Application No. 10/725,971

Amendment dated June 27, 2005

Reply to Office Action of February 25, 2005

## **Amendment To The Drawings:**

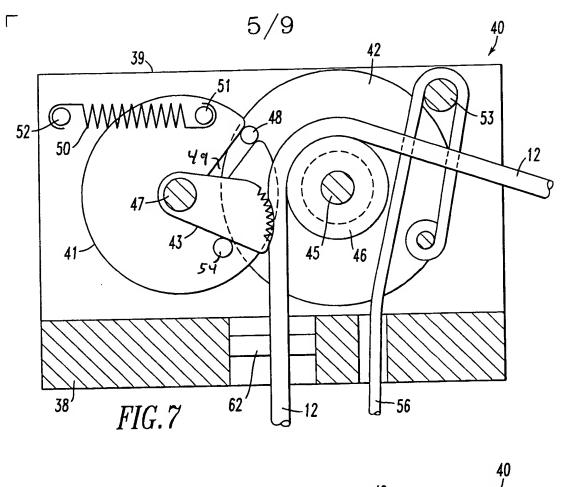
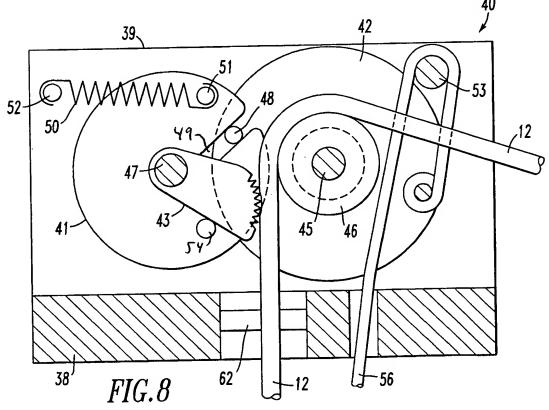
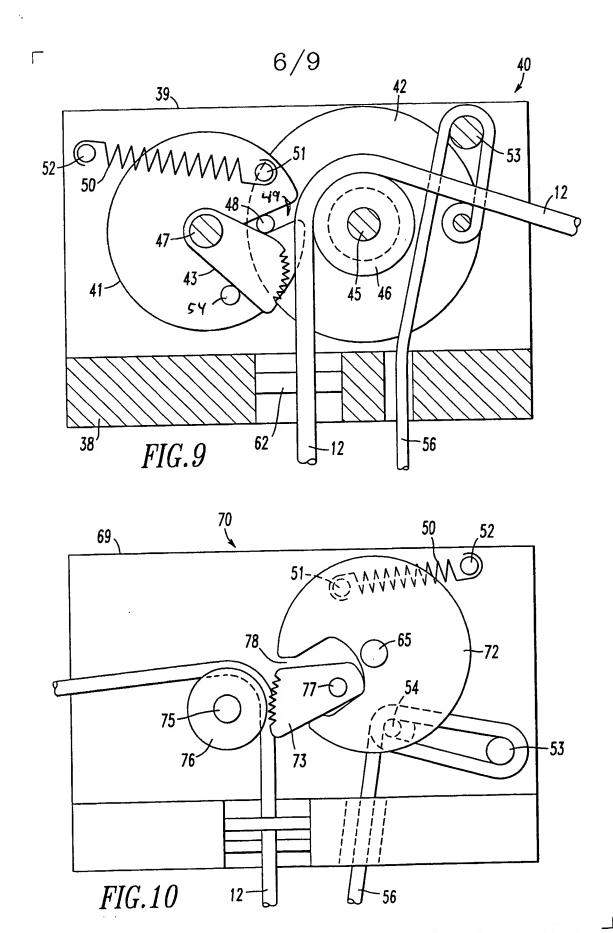
Applicants submit corrected drawing sheets 5, 6 and 7 containing Figures 7 through 12. Reference numbers 49 and 54 have been added to Figures 7, 8 and 9. This correction is made to overcome the Examiner's objection that reference number 49 does not appear in the drawings.

Applicants have also corrected Figure 11 to show multiple wheels 76 and cams 73. Support for this change is in the informal Figure 11 submitted with the application which shows multiple cams 73. It should be noted that the cams in original Figure 11 are inverted making the figure inconsistent with original Figure 10. At page 9, line 17 says "cams 73" clearly indicating that the embodiment contains more than one cam. Corrected Figure 11 is consistent with Figure 10.

Substitute the attached drawing sheets 5, 6 and 7 for the corresponding sheets currently in the pending application.

A copy of these pages as currently pending are also enclosed with changes marked in red.
